ST. TAMMANY PARISH

Addendum No.: 2

Bid#: 24-35-2

Project Name: Diversified Water Well Pretreatment System

SHEET NO.
C-008
 SHEET 19 OF 92

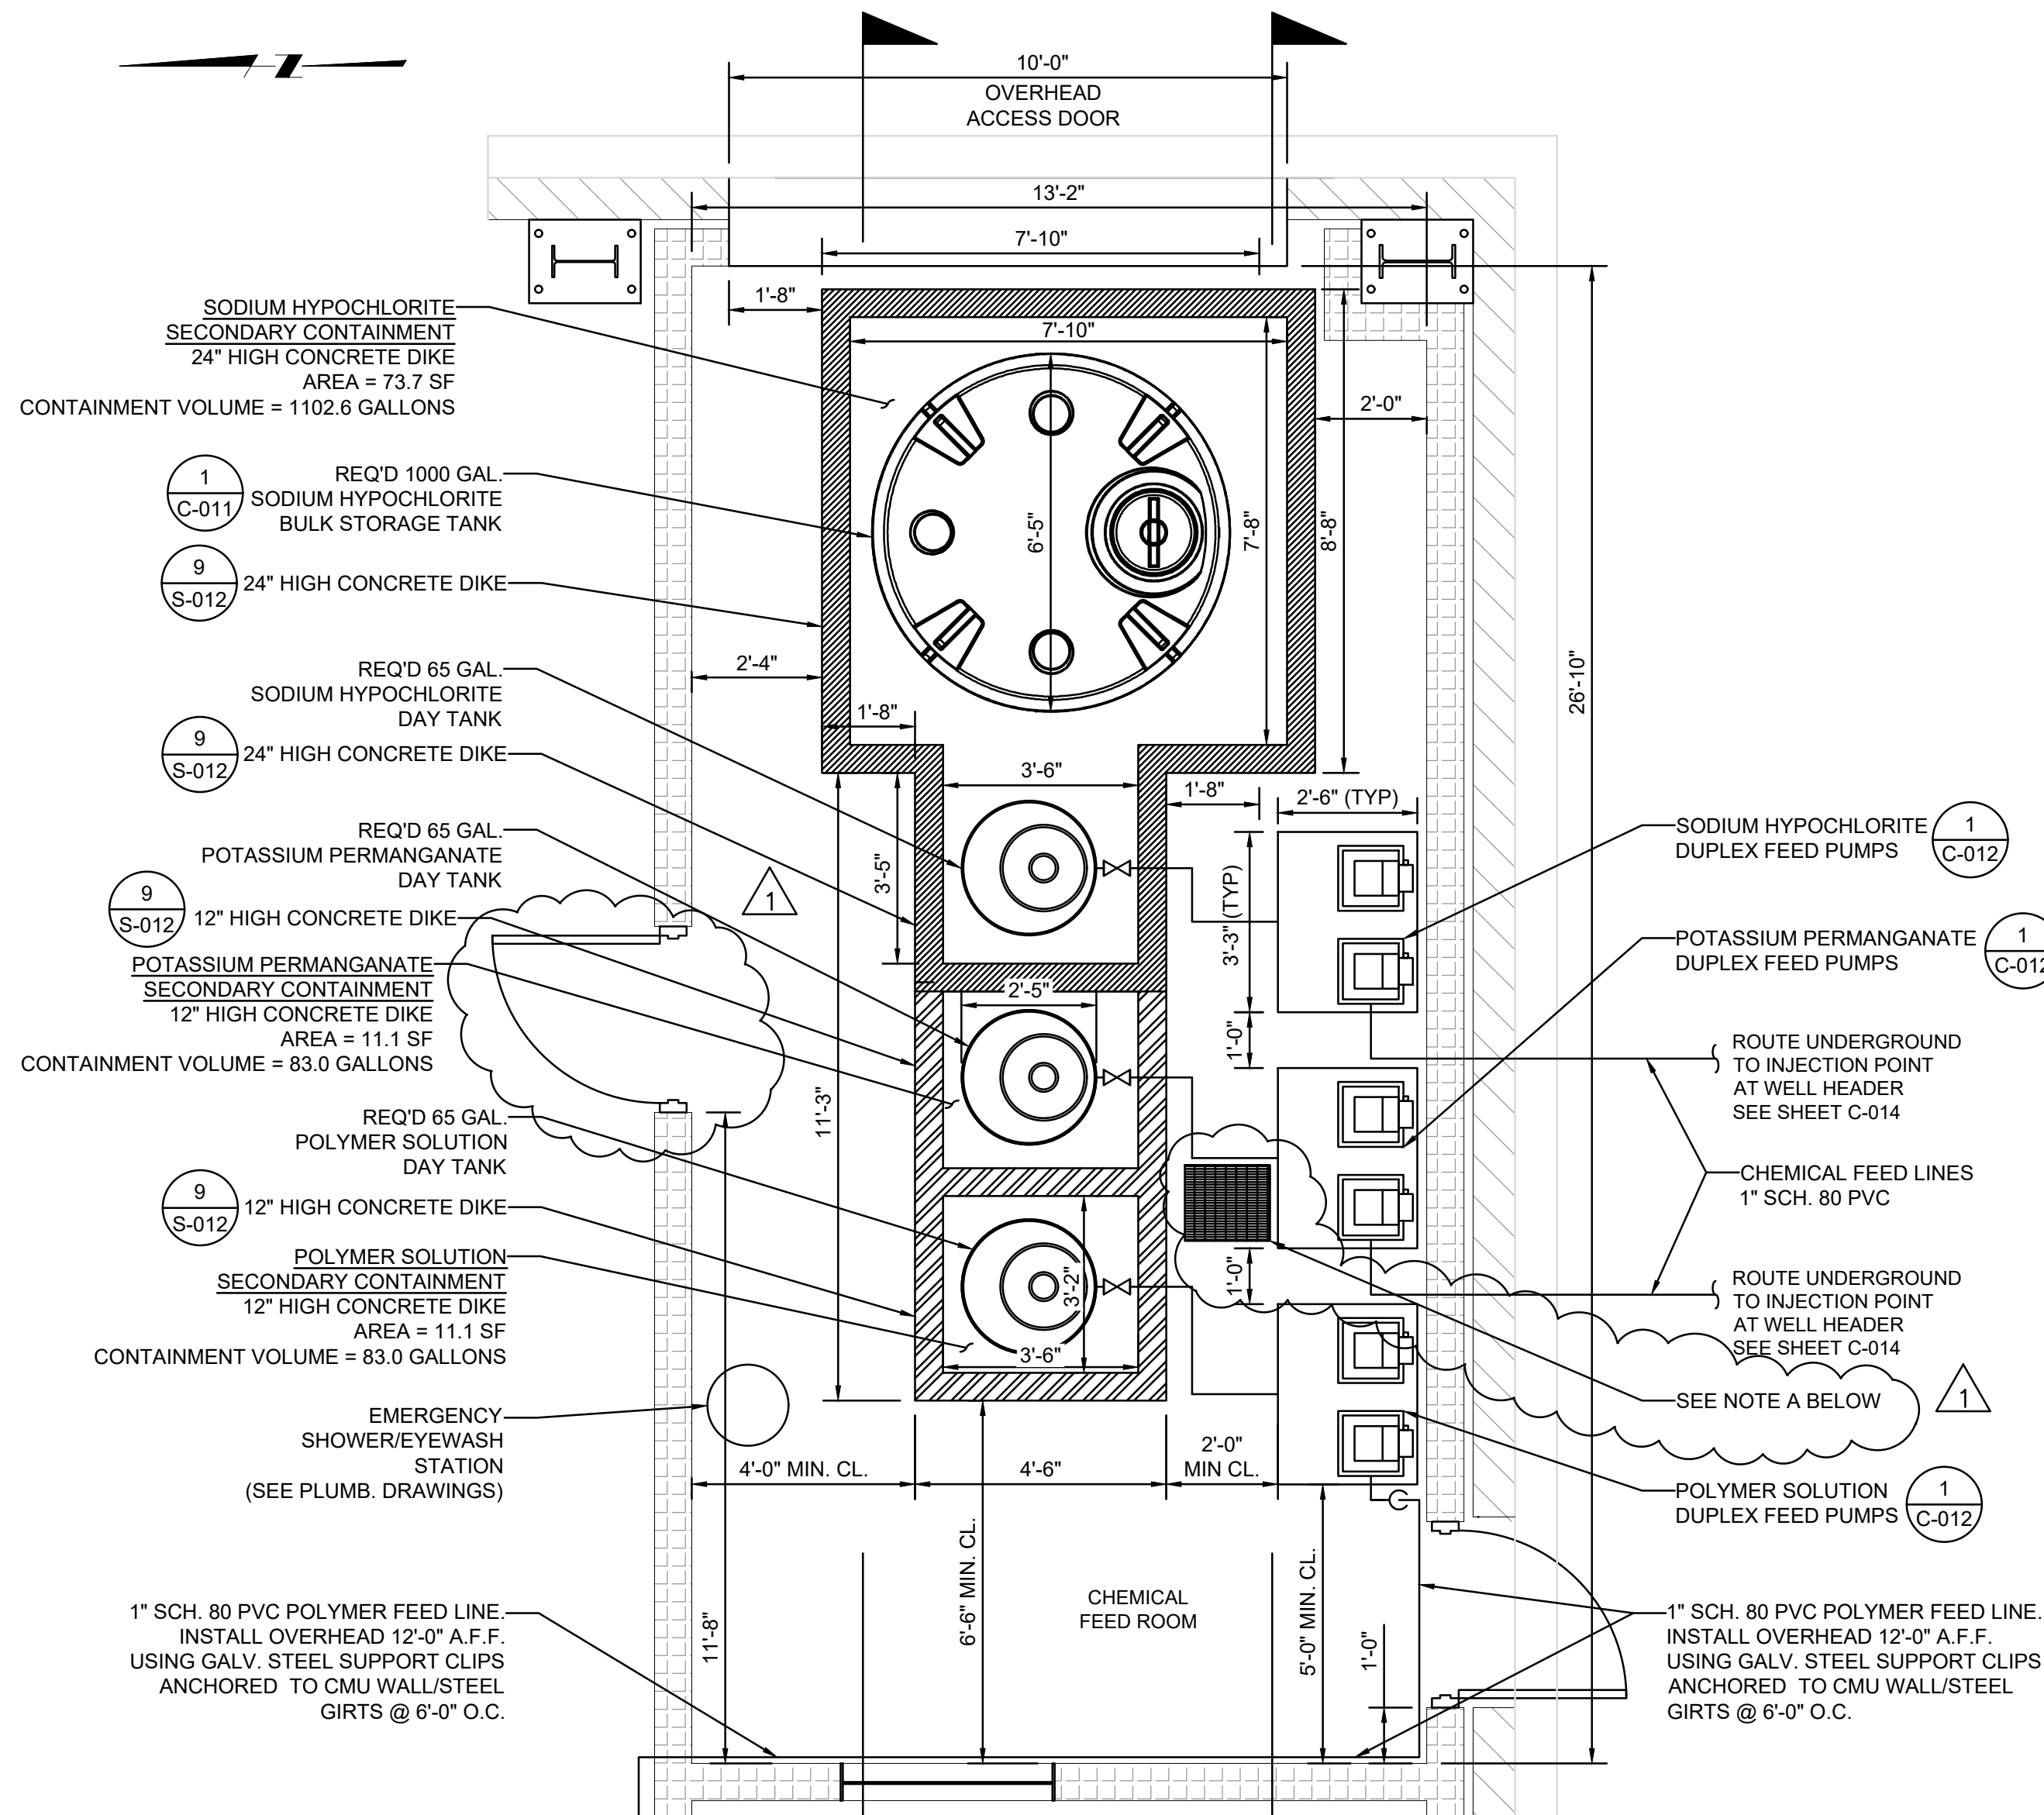
35. **Replace** Plan Sheet C-008 Filter Building Process Cross Section with the attached revised Sheet C-008, showing the 12" magnetic flow meter at the filter effluent header pipe.
